Congregation Beth Ahabah

Design Review

September 9, 2016

Response to CAR Hearing Comments

Left and right bays set back from center to break up primary building facade.

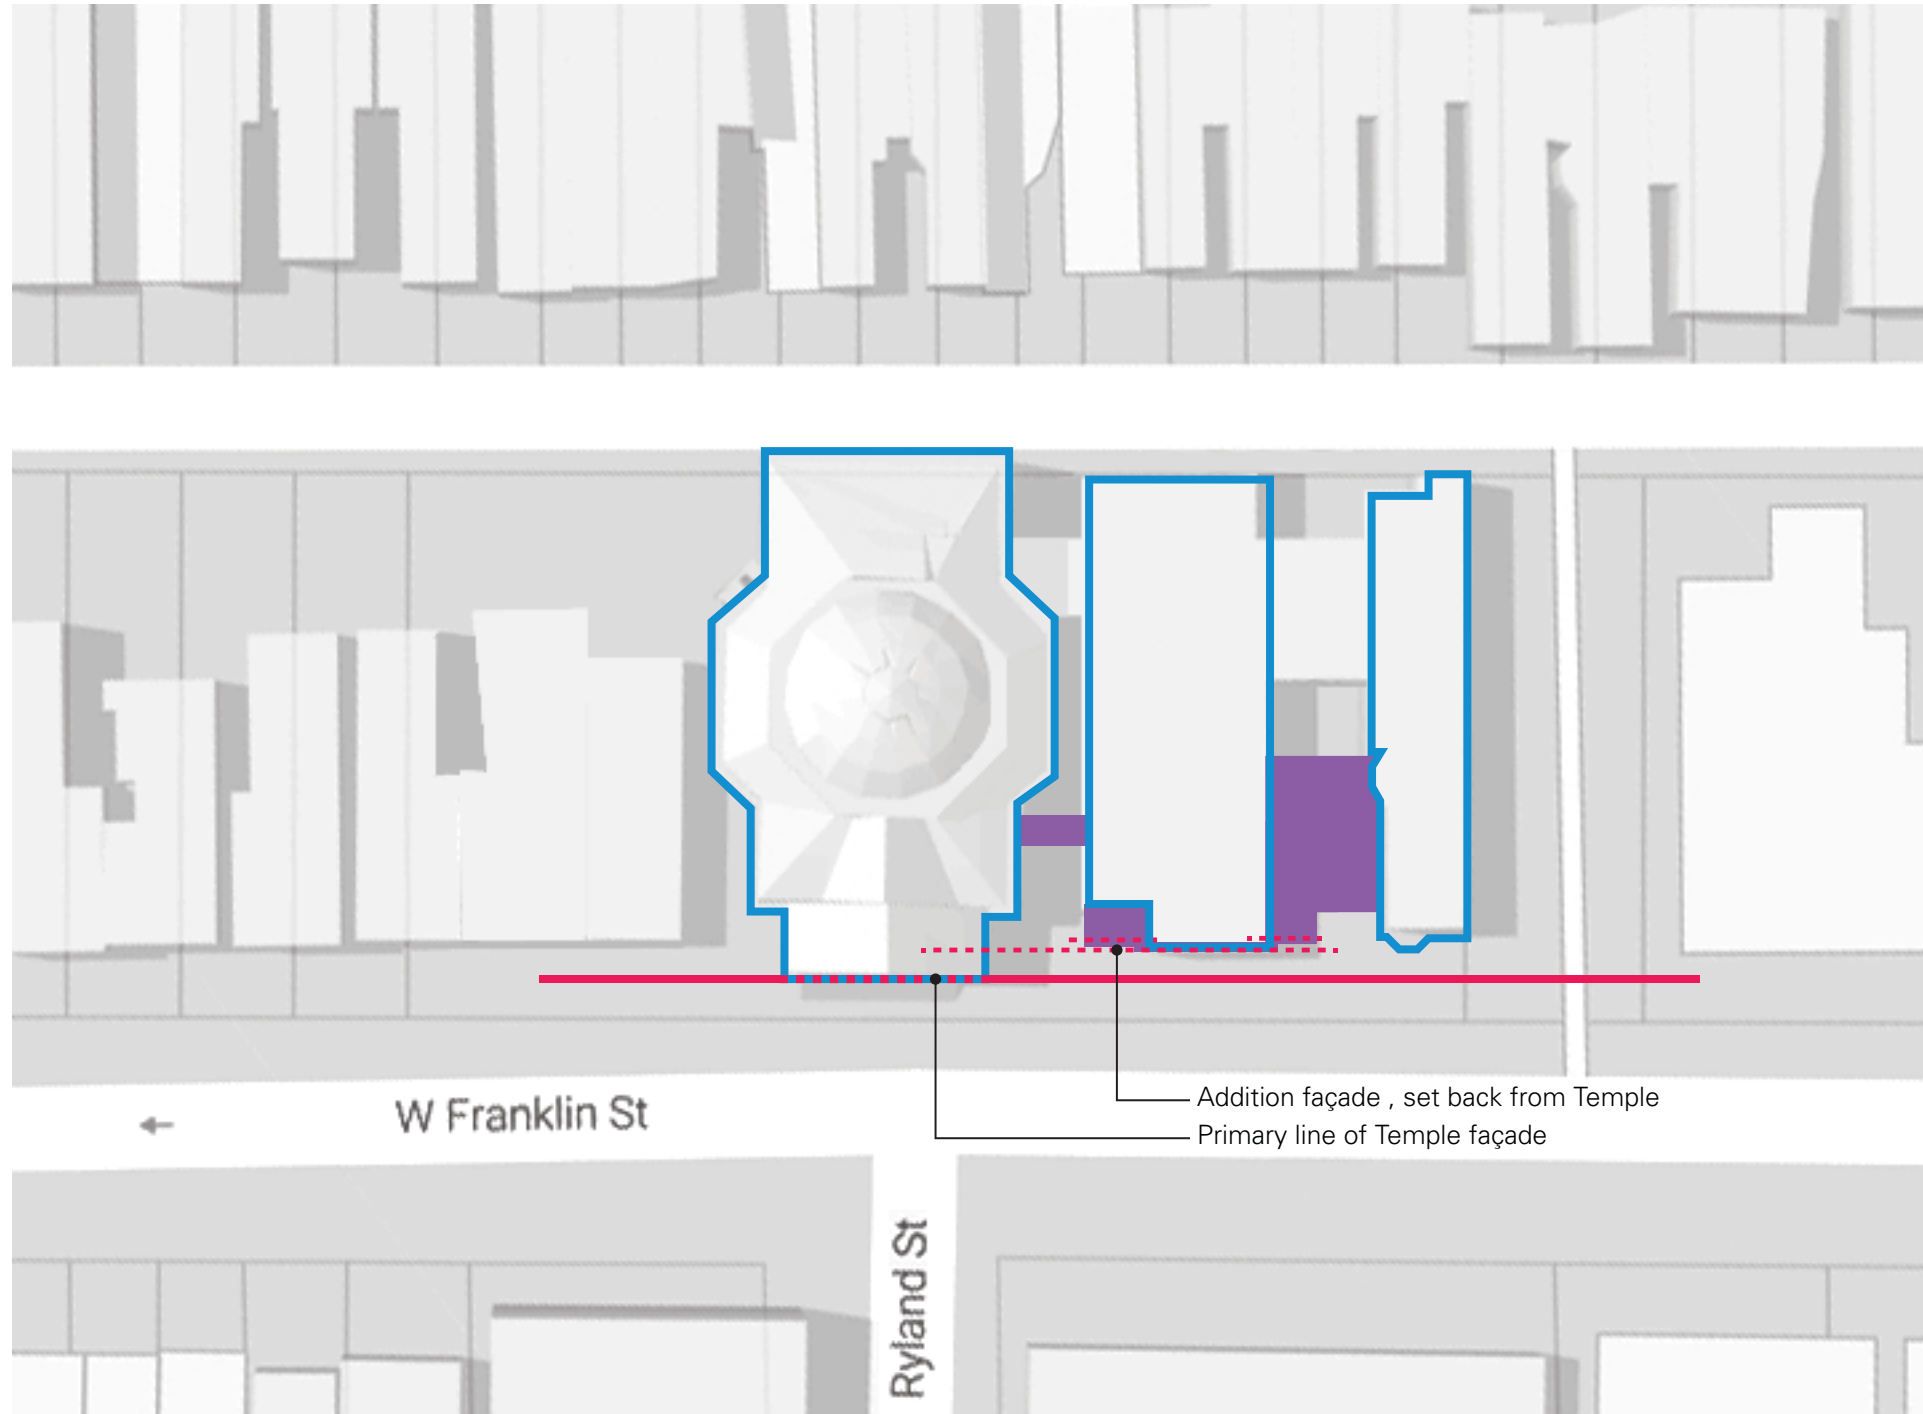
Concern: façade too large; scale not consistent with other buildings in the neighborhood and historic district; review bay structure; suggestion to break façade into 2 or 3 bays.

Response: we have completed a study of buildings within the West Franklin St Old and Historic District and found that a number of buildings in the immediate vicinity are equal to or larger/wider in size than the proposed primary masonry façade of the Congregation Beth Ahabah addition/renovation. There is a mix of institutional, religious, and residential structures. Please see "Site - Building Scale Study" within the presentation for our findings. At the same time, we have adjusted the scale of the proposed façade to address the commission's concerns. The approximately 64-ft wide masonry façade has been reconfigured and broken into 3 bays: the central bay stays at the existing location because of existing masonry stair enclosure (to remain), while the left and right portions of the façade are pushed back to break up the primary plane of the wall. To add another layer of detail to the façade, we have added vertical metal trim panels and other details, which provide structure, order, rhythm, and articulation at a human scale.

Relationship Between Addition Façade and Temple

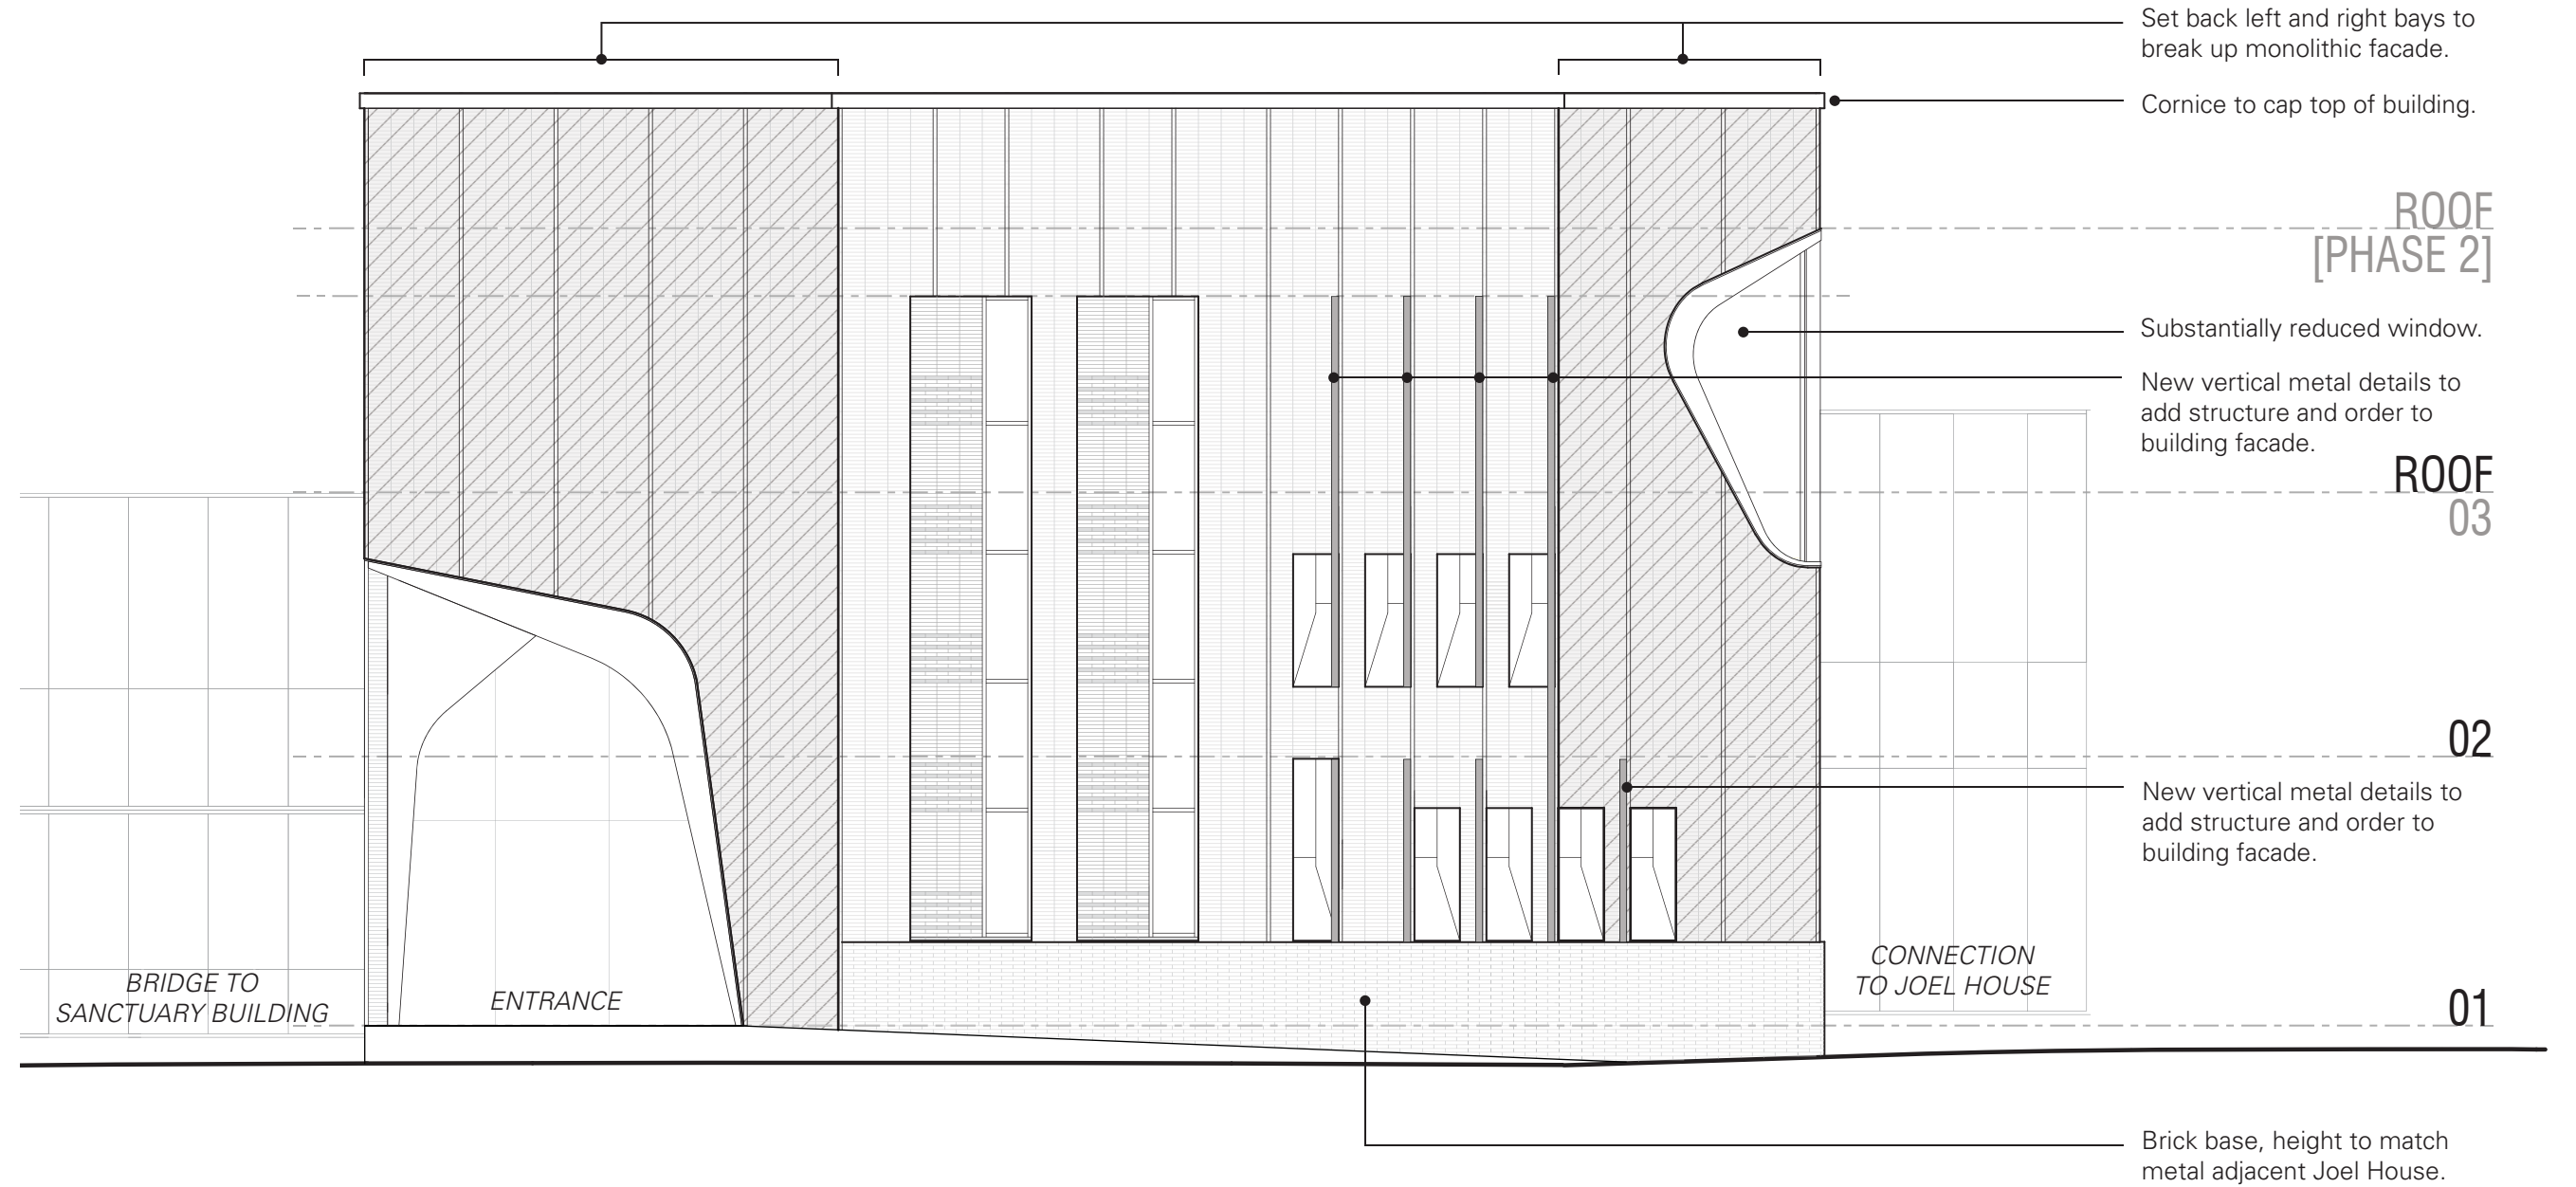
Concern: proposed building façade is not sufficiently deferential to the existing Temple structure.

Response: the proposed addition masonry façade is substantially lower in height than the adjacent Congregation Beth Ahabah structure. It is disconnected from the original synagogue with a glass bridge, which emphasizes the separation between the structures. We have changed the color of the new proposed masonry façade to a darker hue, to create further distinction between the structures. We have stayed away from moving the new main entrance to the center of the addition wall because it is subservient to the synagogue. A central door would mean that this entrance is as important. By having the door to the side, facing the synagogue, there is constant emphasis and dialogue with the historic building. The Temple is an institutional building of substantial size, and the addition façade should be properly scaled not to be dwarfed by the sanctuary building. The question of scale relationship is a core issue, and the buildings making up the Congregation Beth Ahabah campus should be in balance, not mini-imitations of the Temple, nor as small as the scale of surrounding row houses. Our building is a transition structure between the Temple and the residential scale.

Facade Detail Study

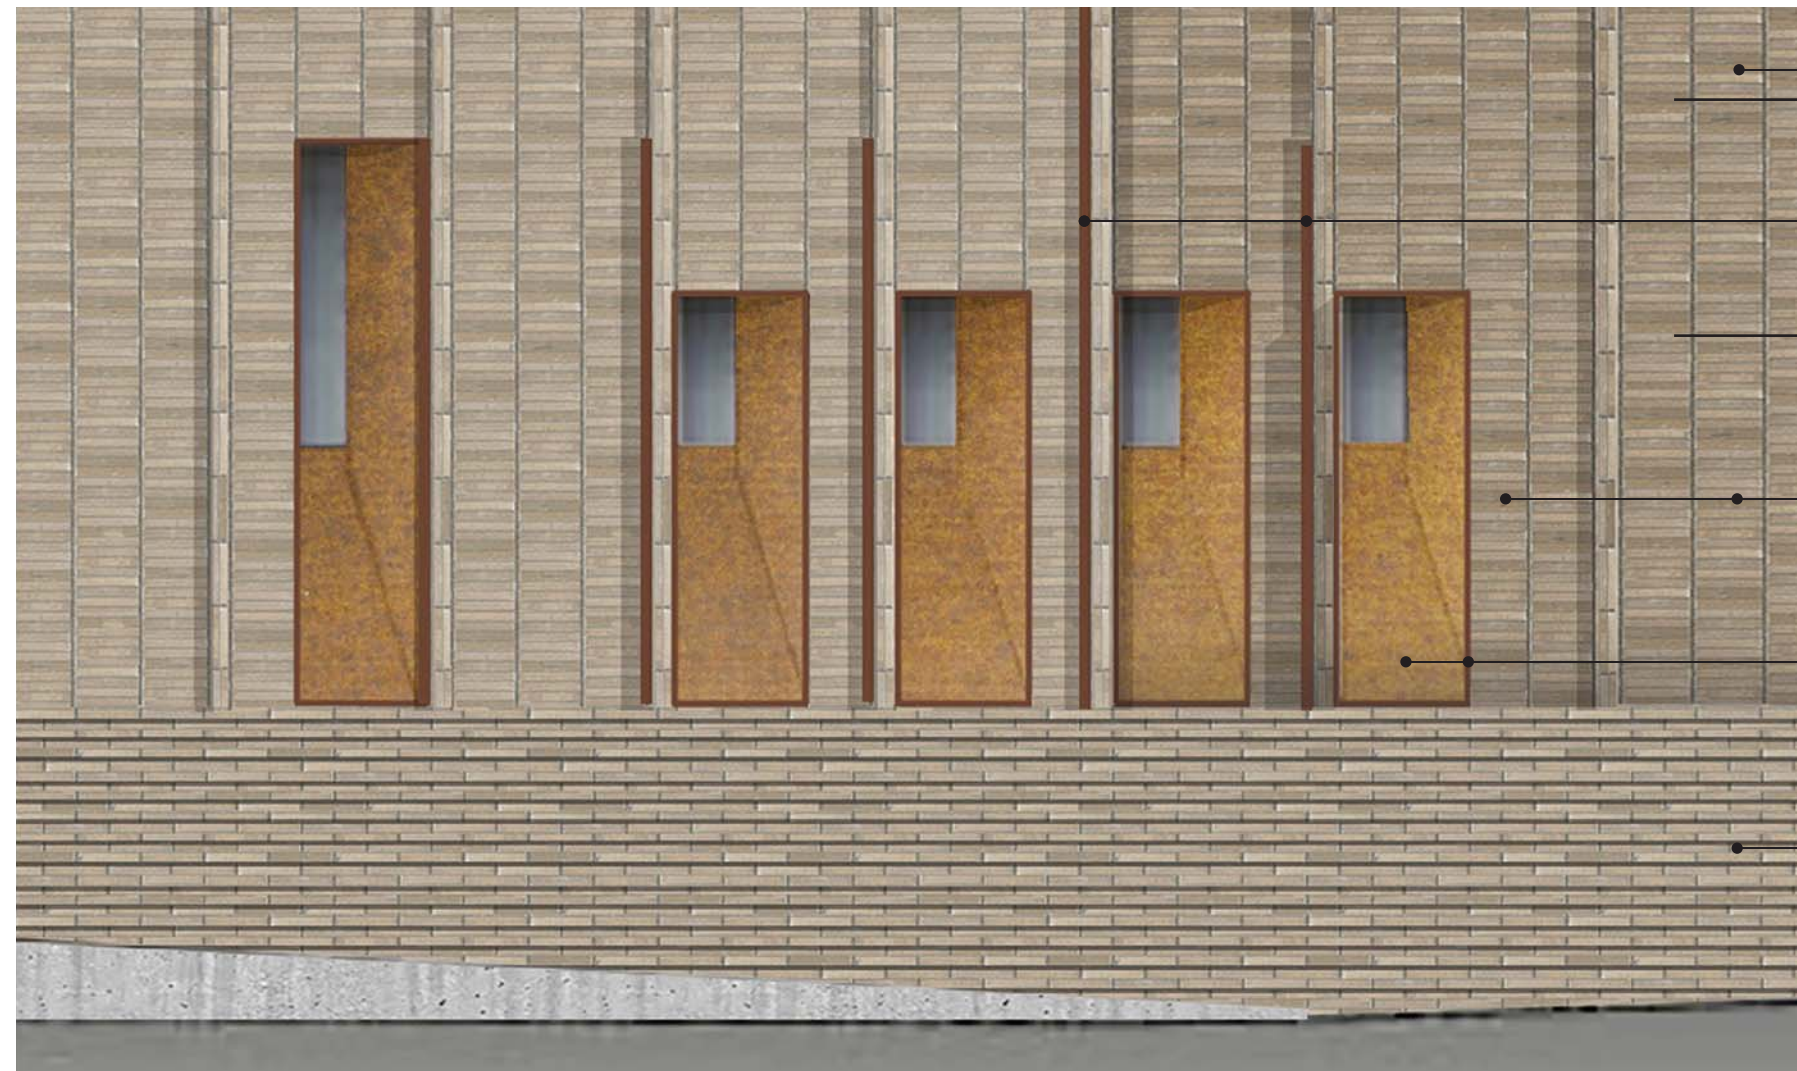
Concern: proposed window arrangement has no clear structure and organization on façade surface; no clearly defined frames or articulation against masonry.

Response: we have added elements to the façade to provide structure and definition to the various components and reinforce the composition. New metal details adjacent at the smaller windows relate to the two tall windows at the left, while providing structure and rhythm to the façade. The tall windows have articulated sills at the base of the opening. We have further refined the organization and design of the small windows, by adding clearly defined metal frames to each, with sills of contrasting material/color. We propose each small window to be framed by a bronze jamb/head/sill, to differentiate it from the surrounding brick surface. The sills will be clad in matching metal. The articulation of the windows as seen in the plan view (see page 13) has enriched building and added depth to the façade.

- A — Darker brick to differentiate from the synagogue brick finish.
- B — Vertical metal details, to add structure and rhythm to the façade.
- Wall surface set back from center bay to break up monolithic façade.
- Articulated metal sill and window surround, creating added interest and detail at human scale.
- Textured brick base to match building façade aesthetically and differentiate surface from wall above; height to match porch height of adjacent Joel House and emphasize the horizontality of the street wall.
